Minutes  
of  
**60<sup>th</sup> PCC meeting**

**Date: 31.10.2017**  
**Eastern Regional Power Committee**  
**14, Golf Club Road, Tollygunge**  
**Kolkata: 700 033**

## MINUTES OF 60<sup>TH</sup> PROTECTION SUB-COMMITTEE MEETING HELD AT ERPC, KOLKATA ON 24.10.2017 (TUESDAY) AT 11:00 HOURS

# OBSERVATION FROM DR

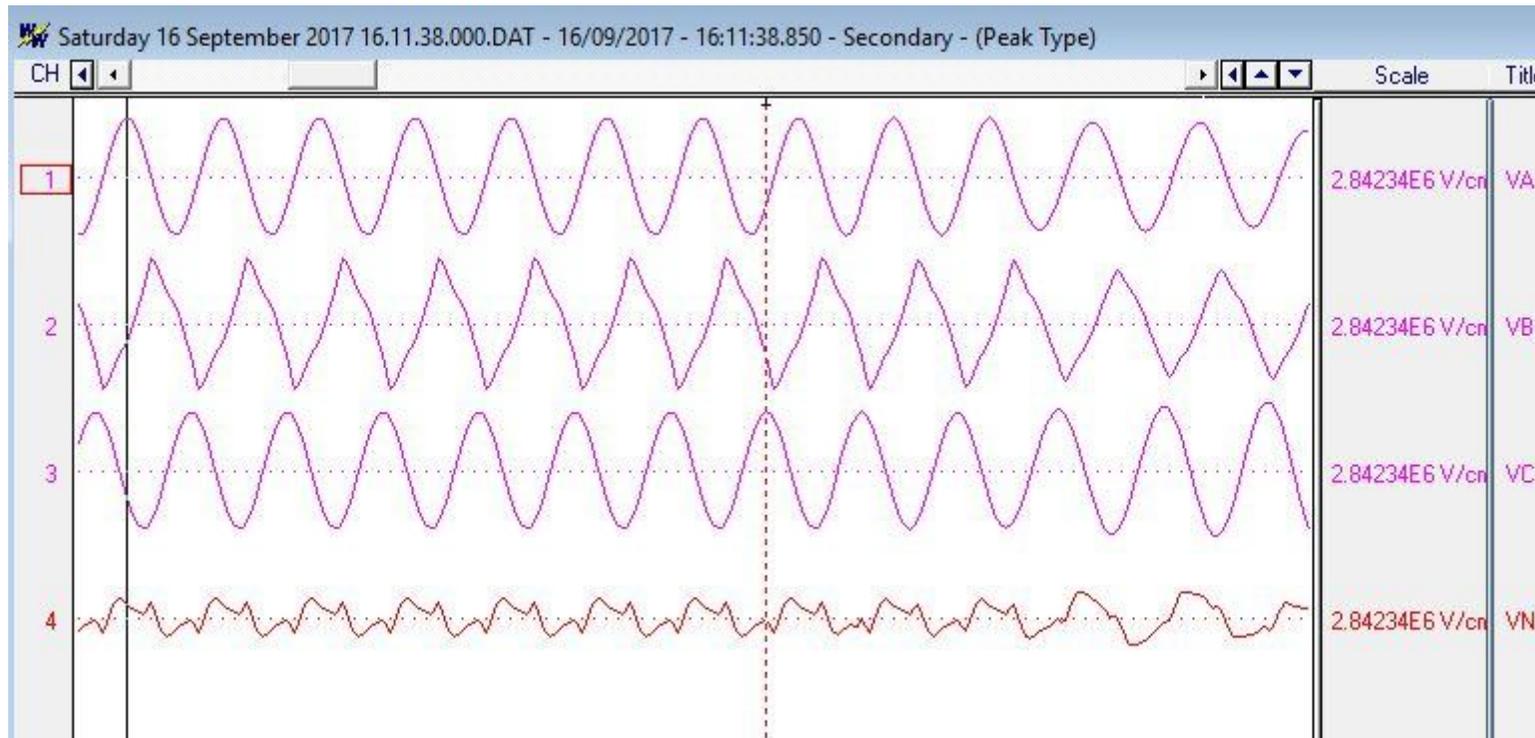
B-phase voltage waveform is distorted and that is triangular like wave form. In the next slide harmonic content of this is shown

# CONT...

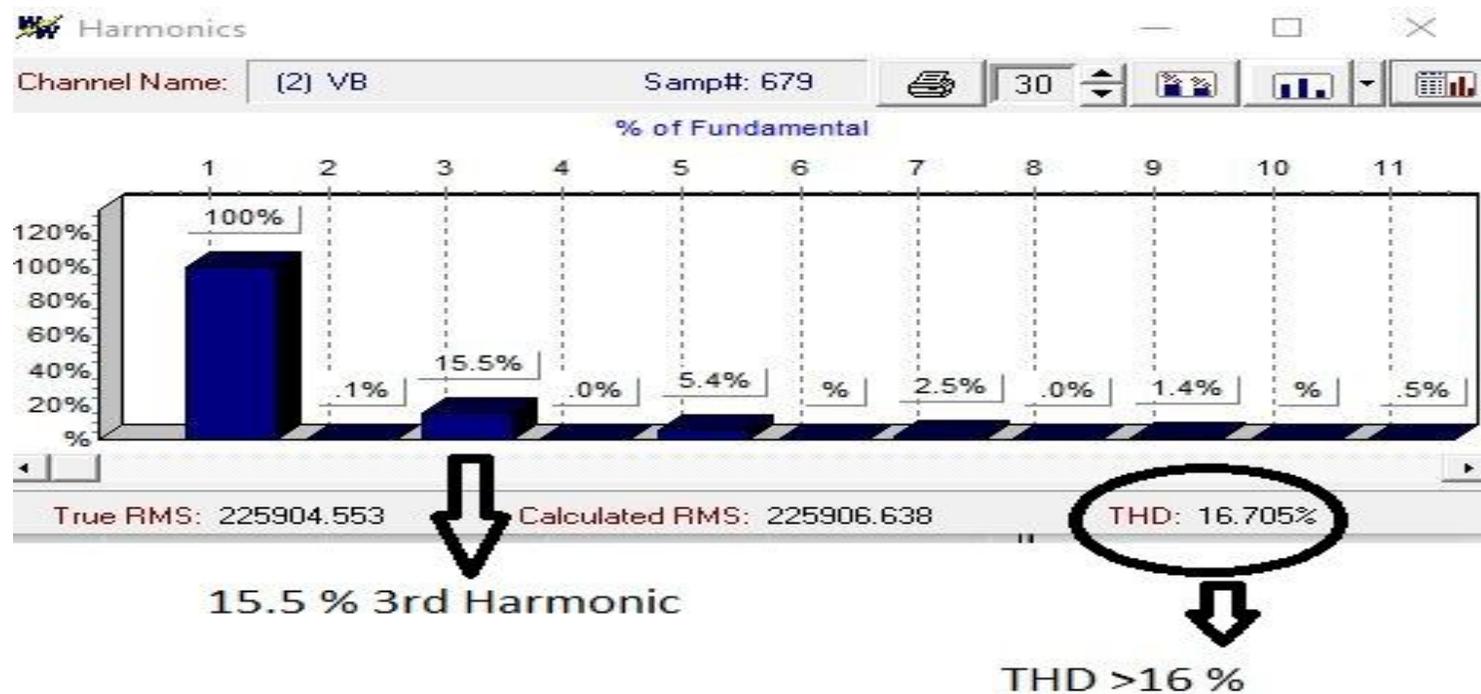
Continuously Harmonic content was **much above acceptable standards** before the tripping took place . Specially the triplen harmonics of 3<sup>rd</sup> and 21<sup>th</sup> order.

Fig.2.6: Example of relative transformation ratio of a 220kV CVT [22]

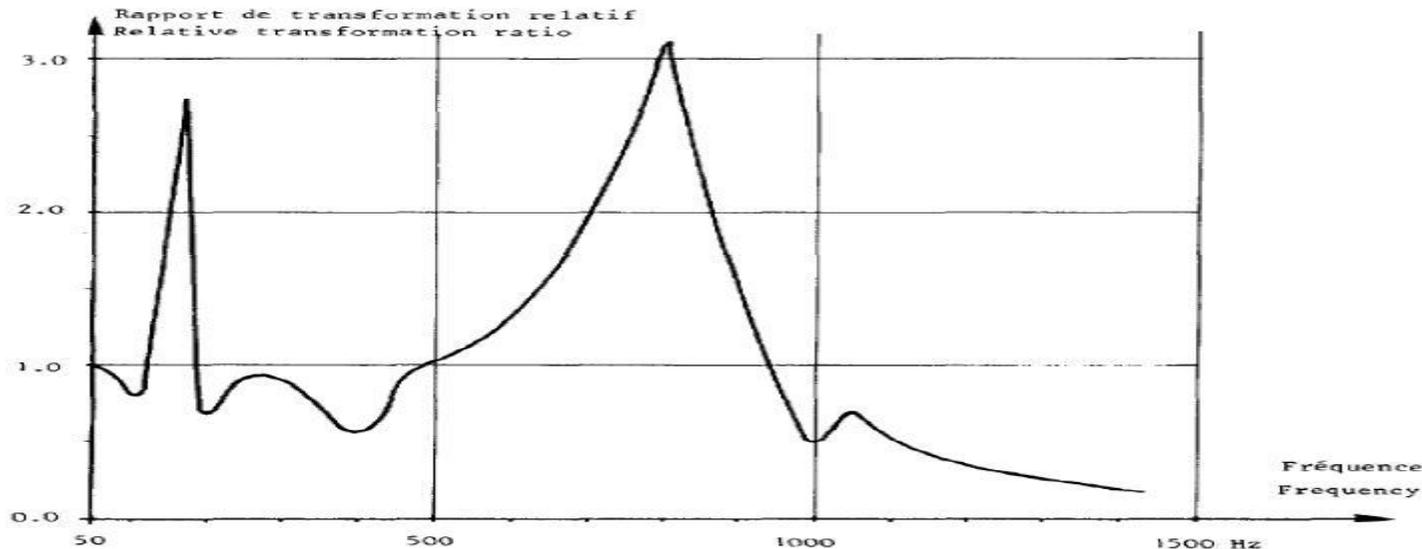
As shown in Fig.2.6, the CVT has a severe response fluctuation. **A resonance occurs near 150Hz**, which is caused by the coupling of the capacitive divider and the inductive step down transformer of the CVT. As indicated in the graph, the frequency bandwidth of the CVT is less than 100Hz with the consideration of 5% accuracy.

# 400KV NEW PURNEA-BIHARSARIFF-II TRIPPING ON O/V ON 05-08-17 AT 13:44 hrs

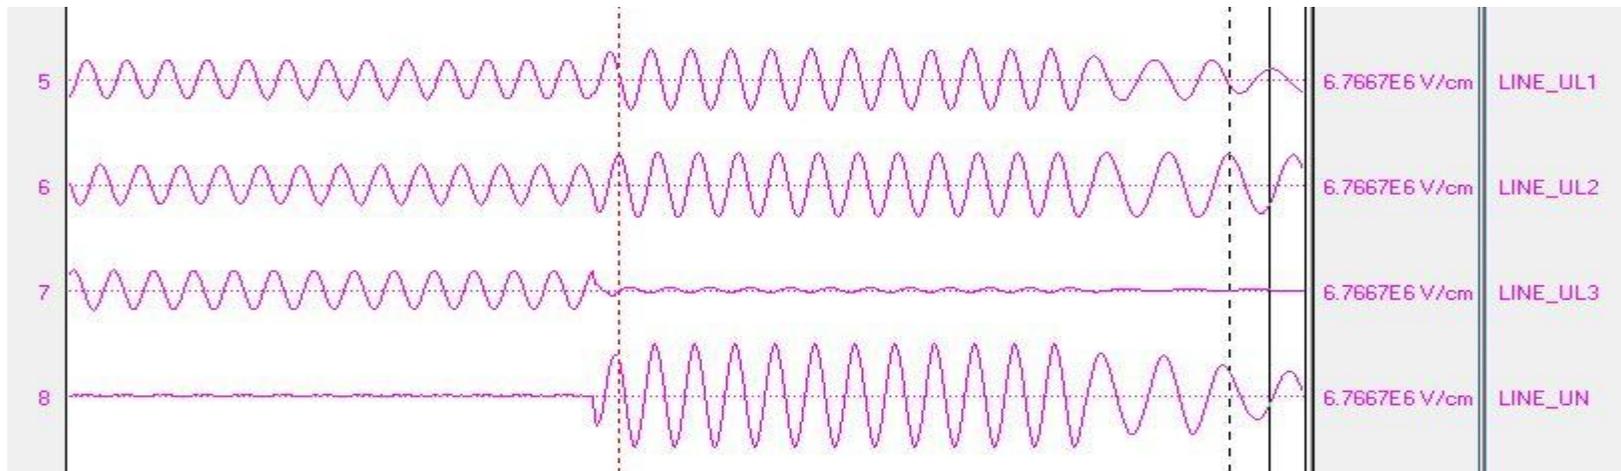
- Tripped on over voltage but system voltage was normal as per PMU . DR is as follows :

Suddenly voltage of C-phase disappear and Fuse failure function of CVT rightly activated . But though there was no fault in the system and no change in current still **other two phase voltage shoot up** . And o/v stage two operated.

- Why are voltage of C phase disappear ?  
POWERGRID may explain .
- Why the voltage of other two phase shoot up?  
While there was no voltage rise in the system  
as clear from Biharshariff PMU . Is it CVT  
problem of that particular line ? Then what  
could be its cause. POWERGRID may explain

On 17.05.2017 at 15:05:14 hrs. 400 KV Biharshariff-Varanasi-I

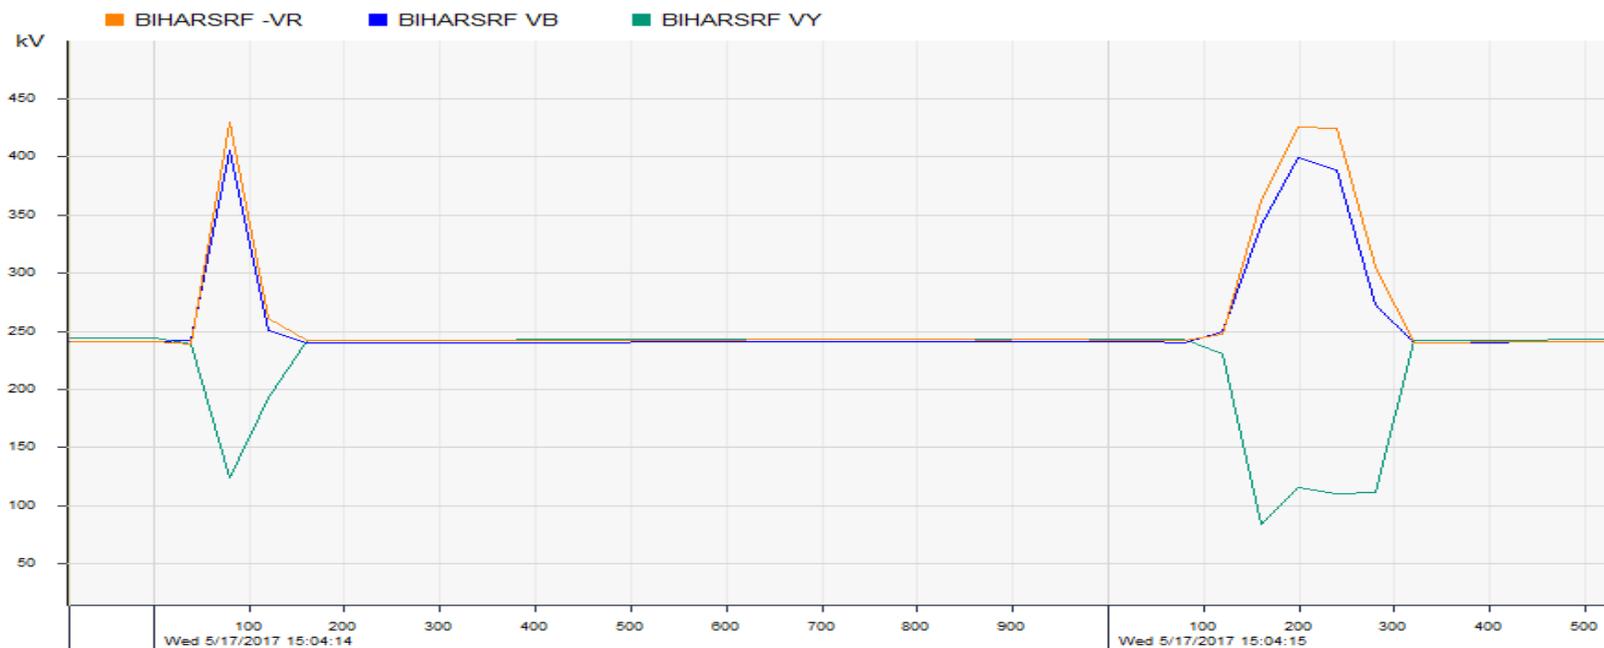
PMU PLOTS OF SUCH HIGH VOLTAGES DURING SLG FAULT AT BIHARSHARIFF PMU ARE AS FOLLOWS:

Disturbance at Biharshariff on 25-09-17 at 09:32 hrs.

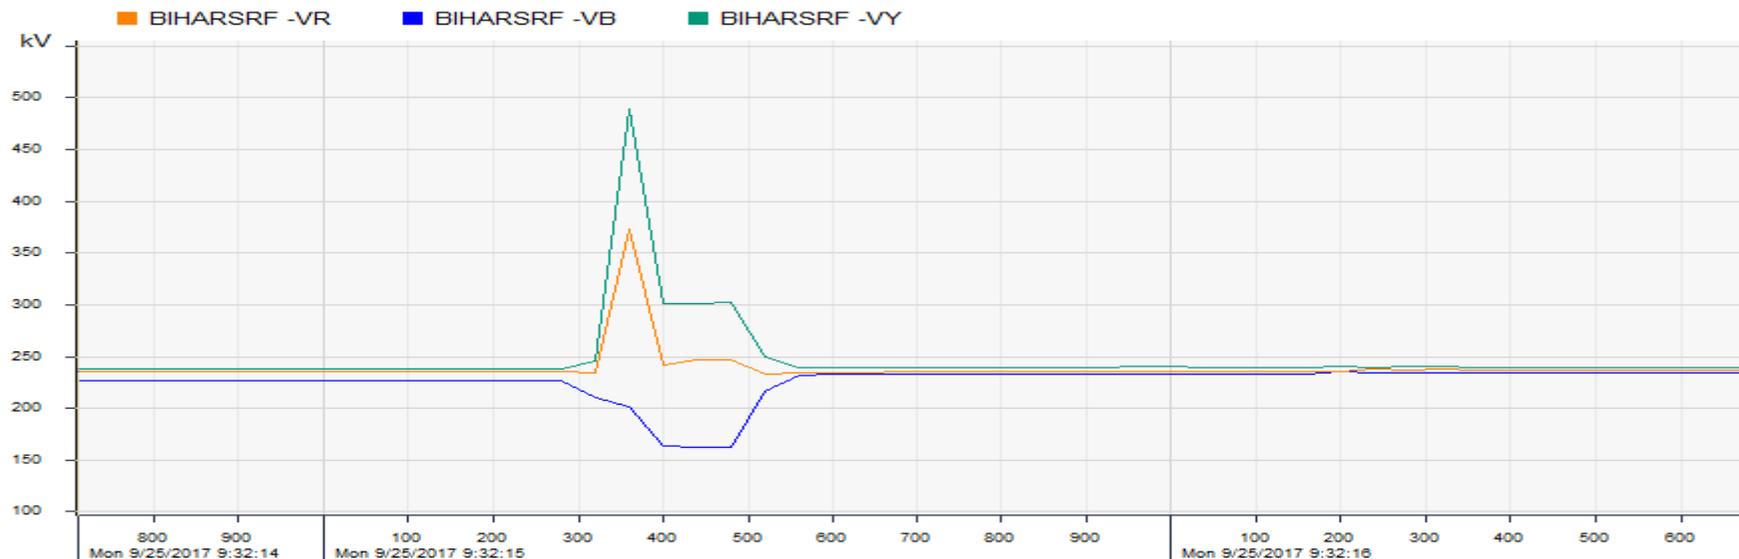
In almost all the cases of SLG faults near Biharshariff some voltage rise in healthy phases are observed in Biharshariff PMU. For the above cases rise of voltage are **alarmingly high**. In our PSCAD study we have seen that for  $Z0/Z1$  of 5 and more may cause healthy phase voltage rise up to 1.5 PU.
